# SCI-823-0.00

**S.R. 823 OVER PORTSMOUTH-**

**MINFORD ROAD (S.R. 139)**

**STRUCTURE TYPE STUDY SUBMITTAL**

2 site plans

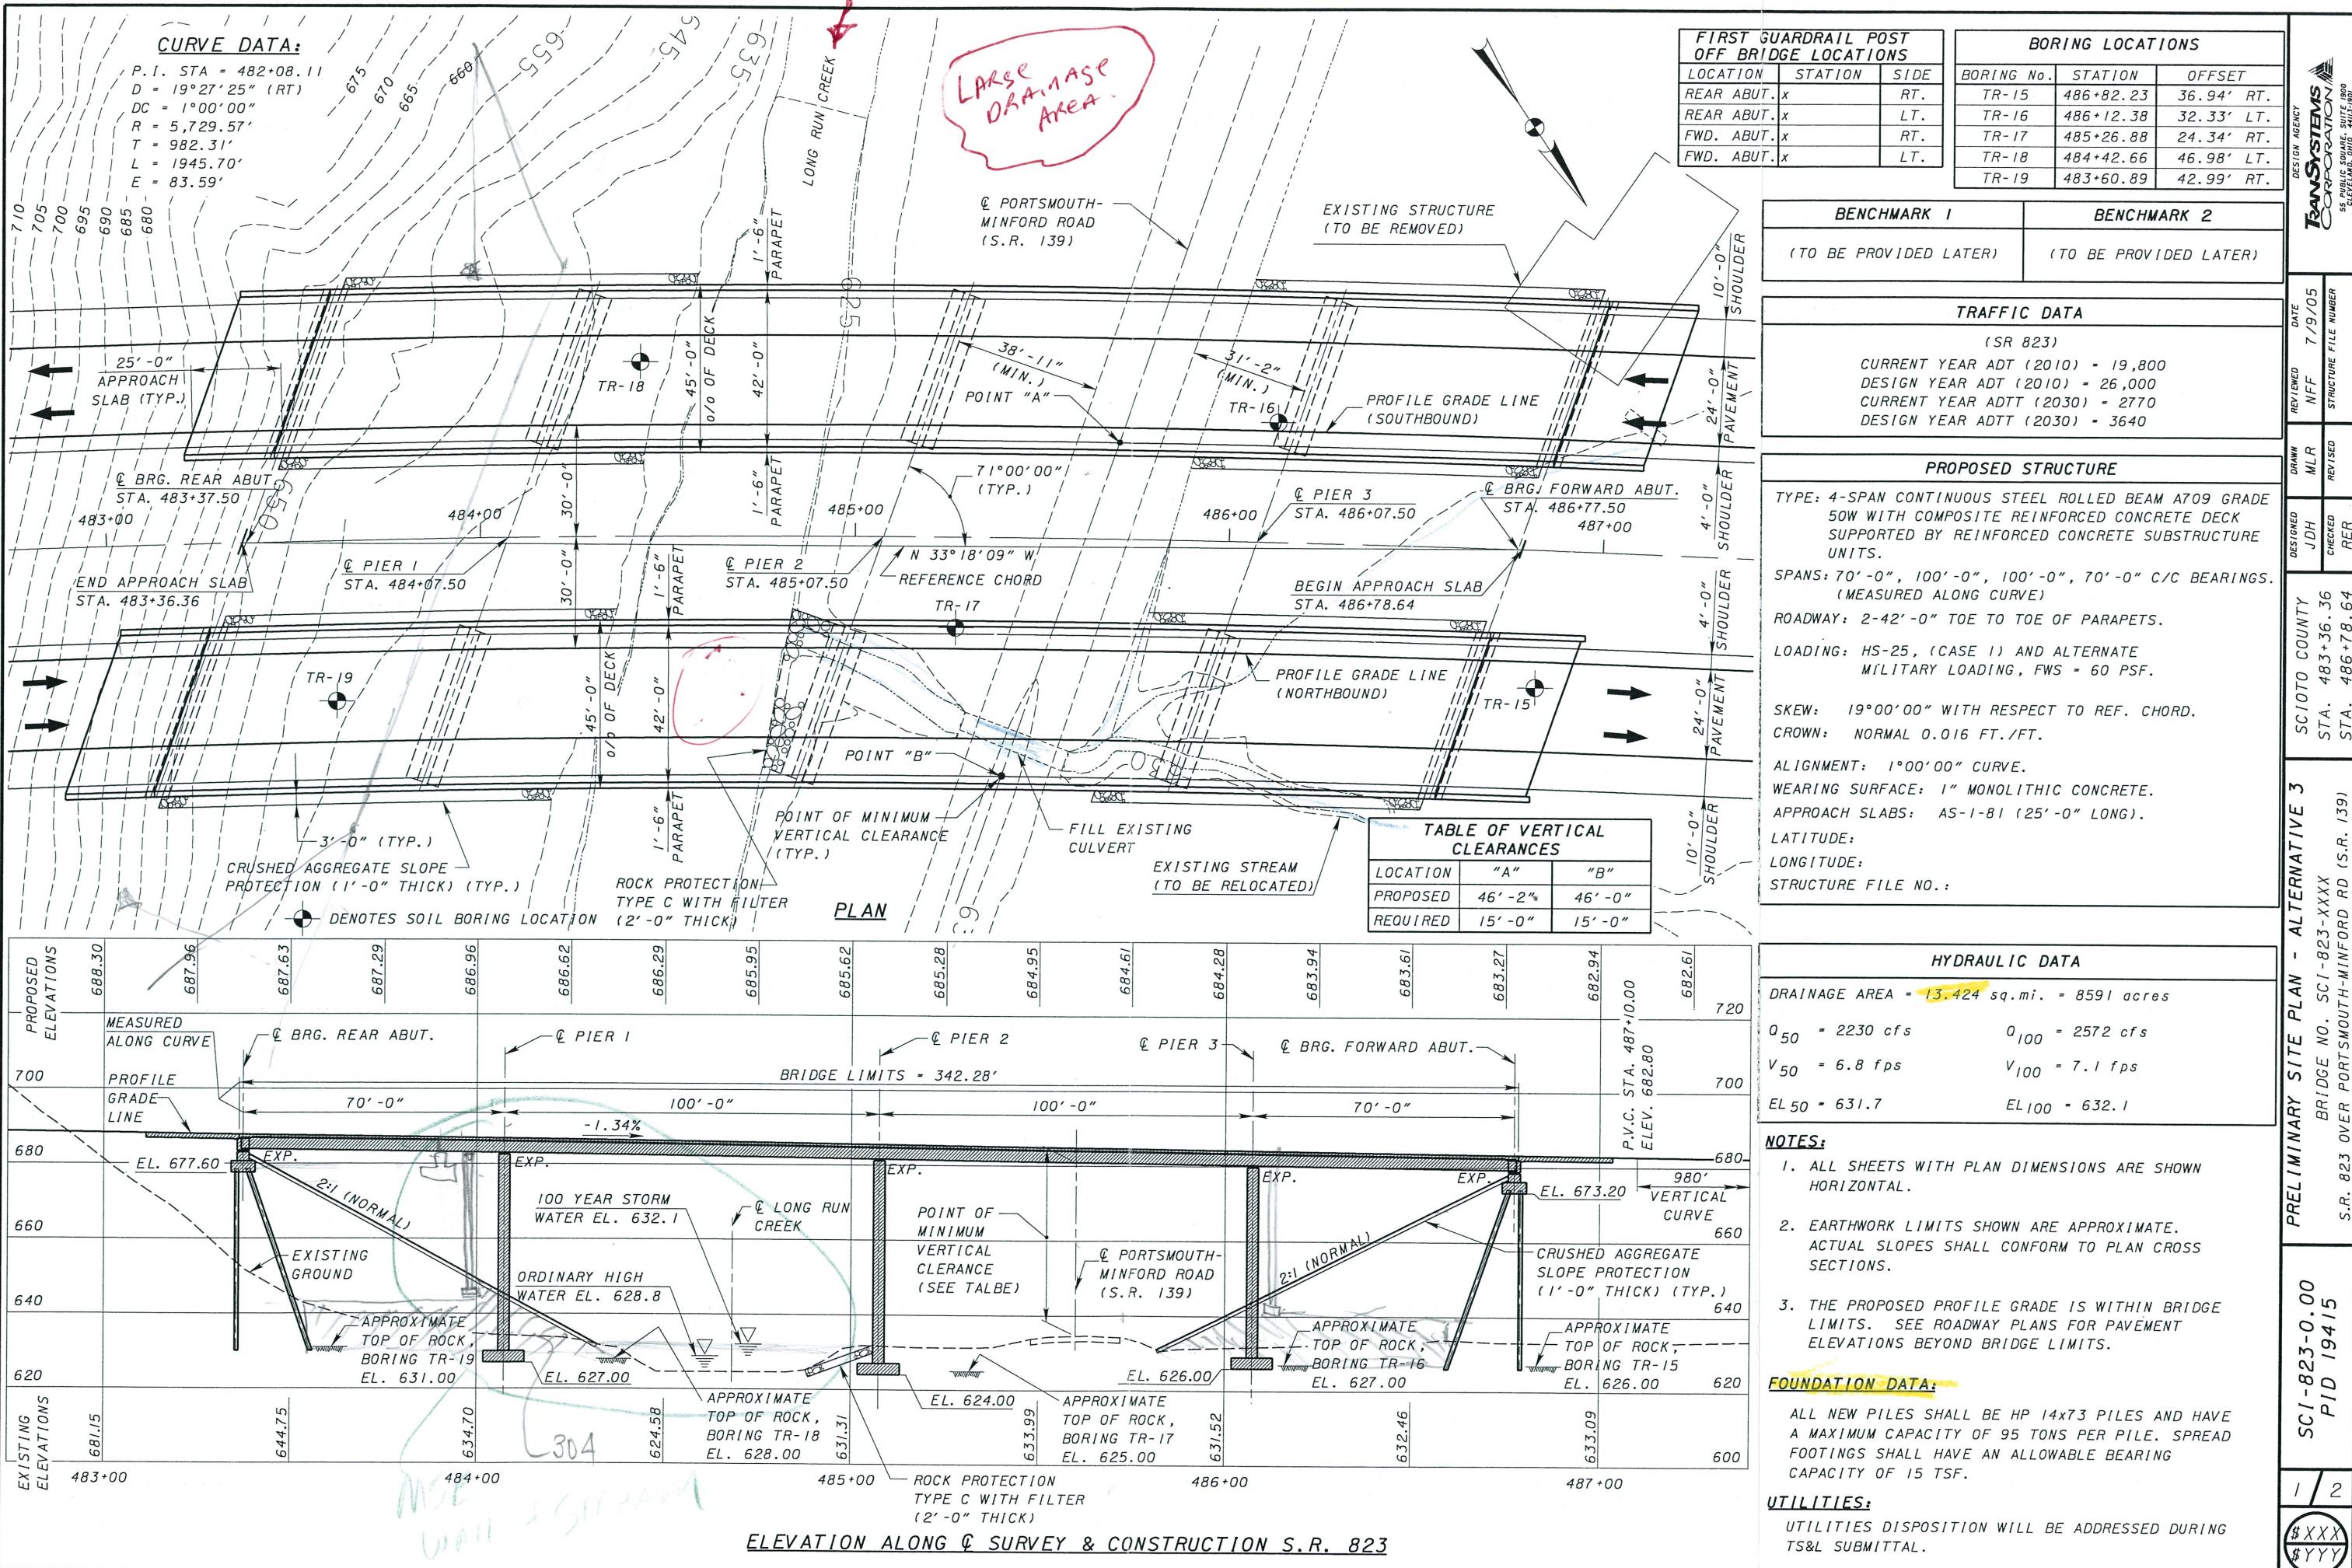
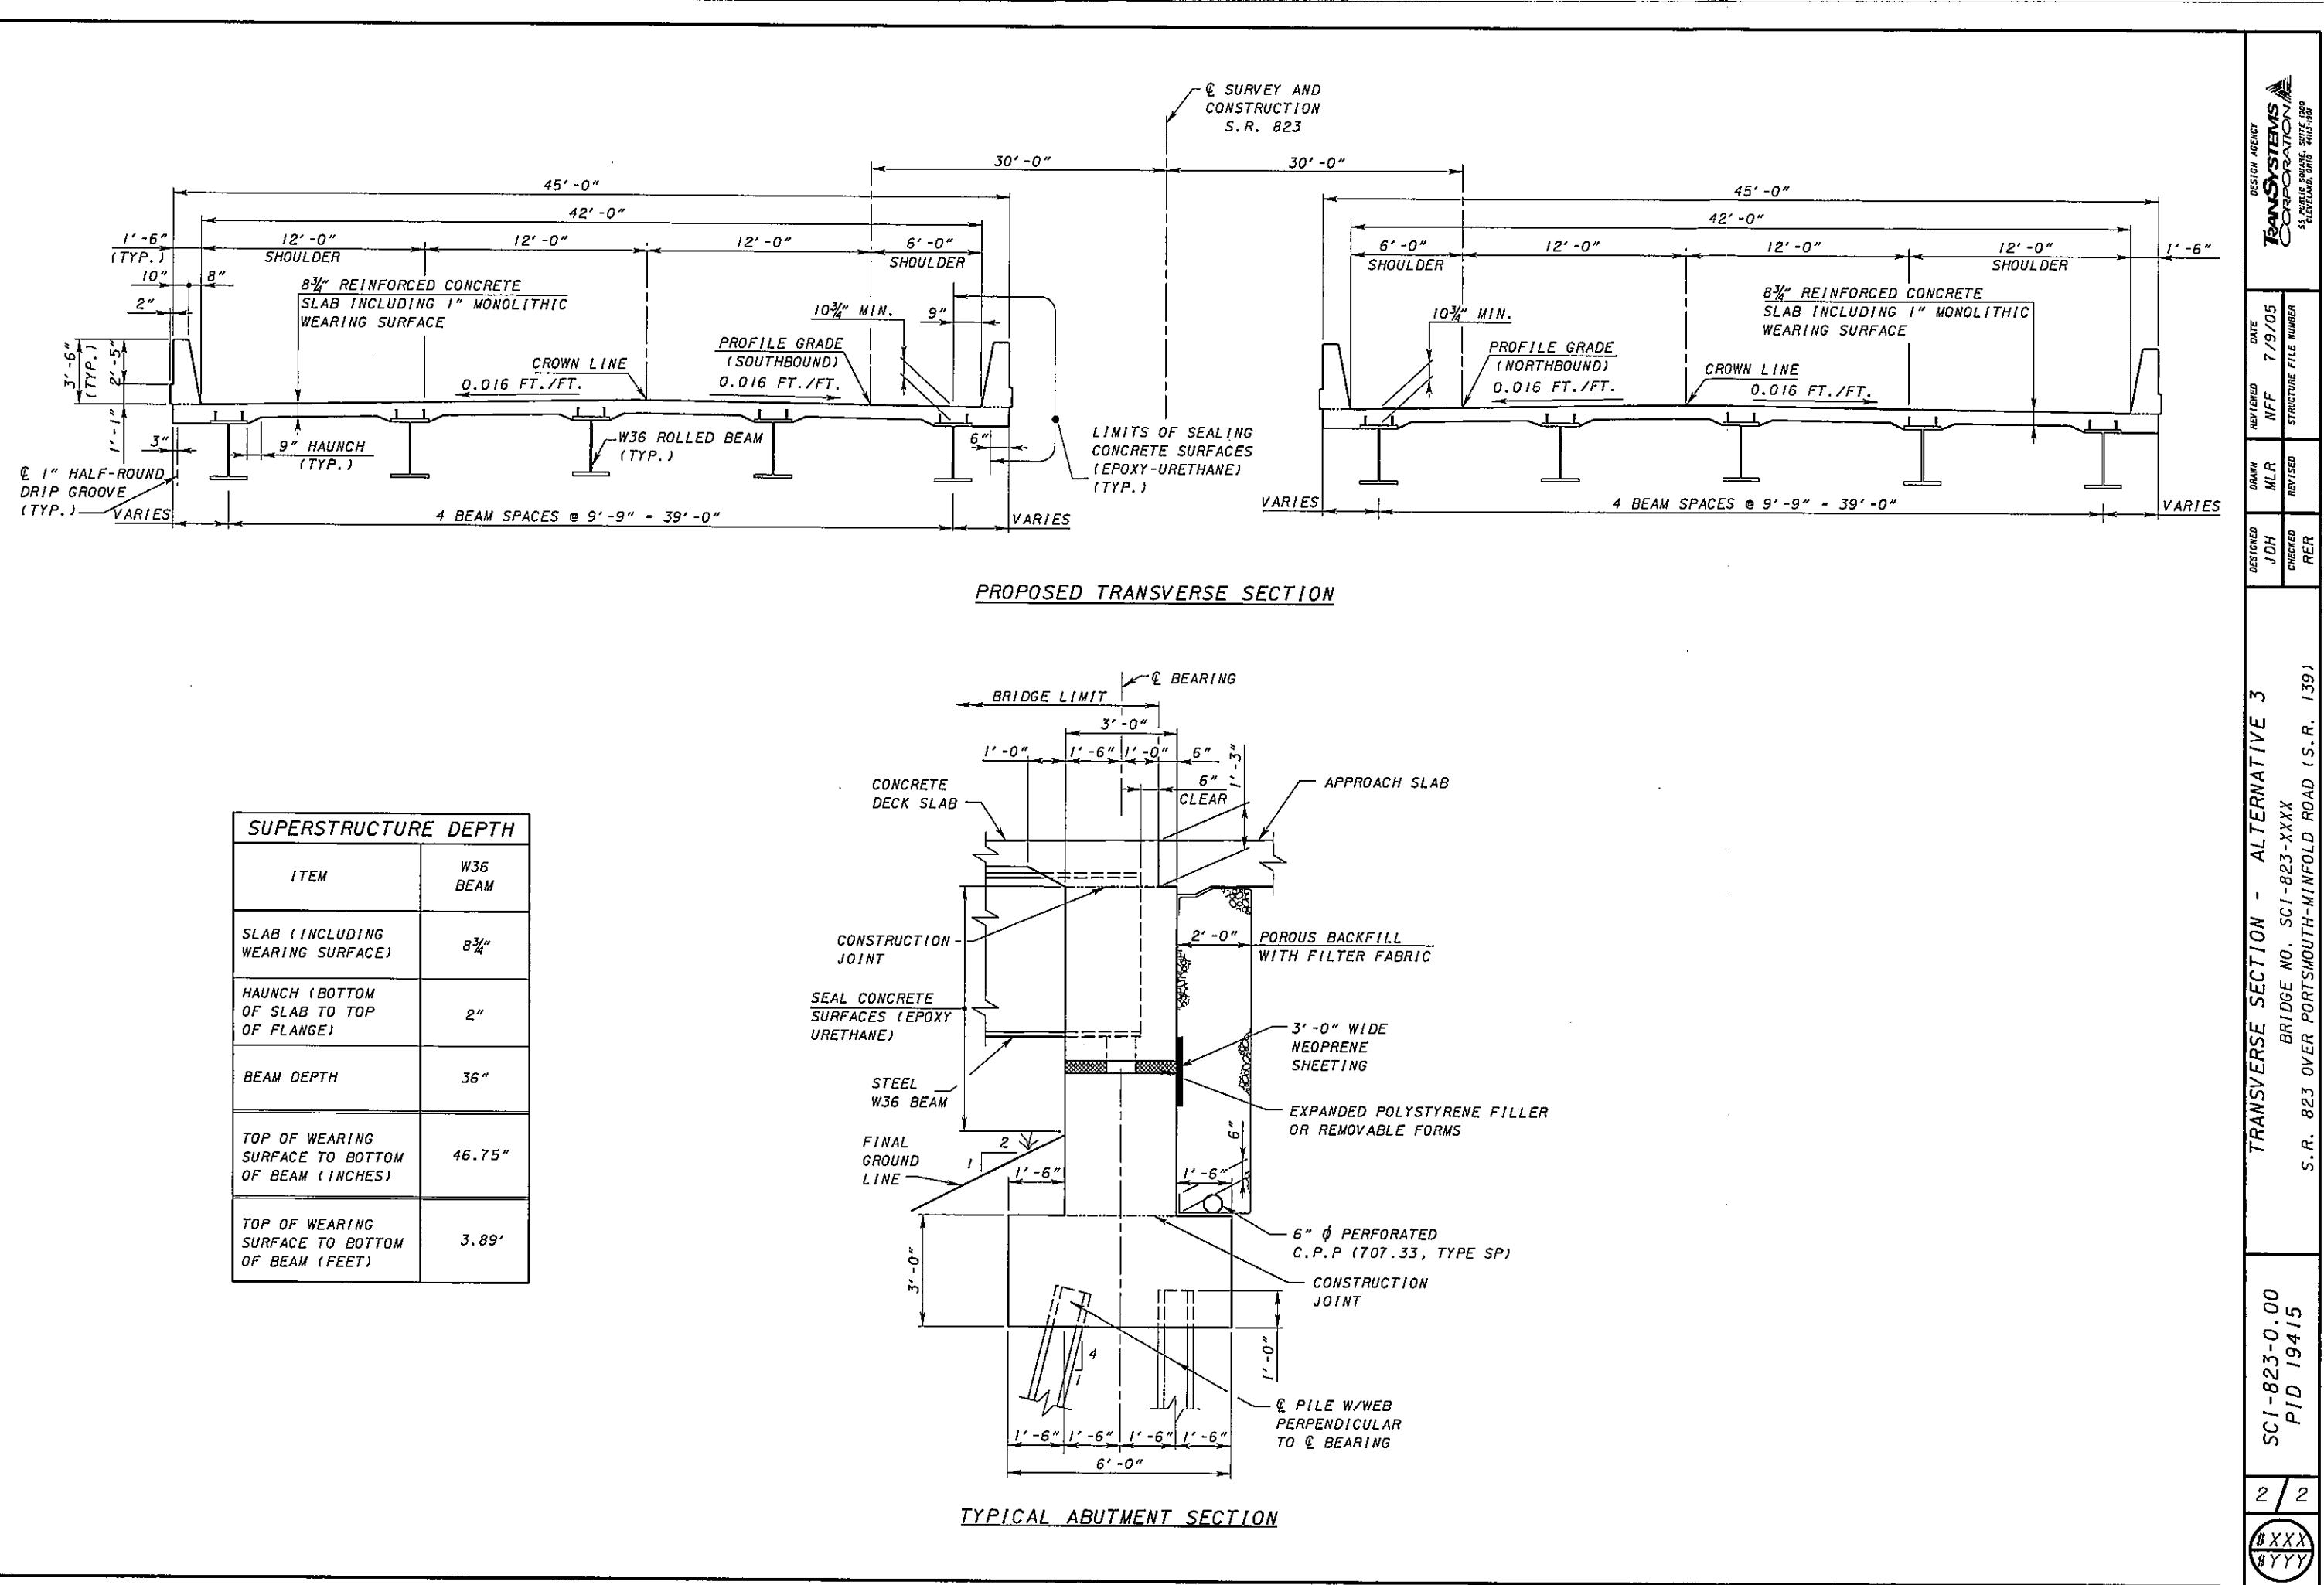
40'-45' MSE walls

what about stream?  
wjk

Undercut

Turned back

40'-45'

Leveling pad — coping

T-type piers

40 scale  
X + 1.
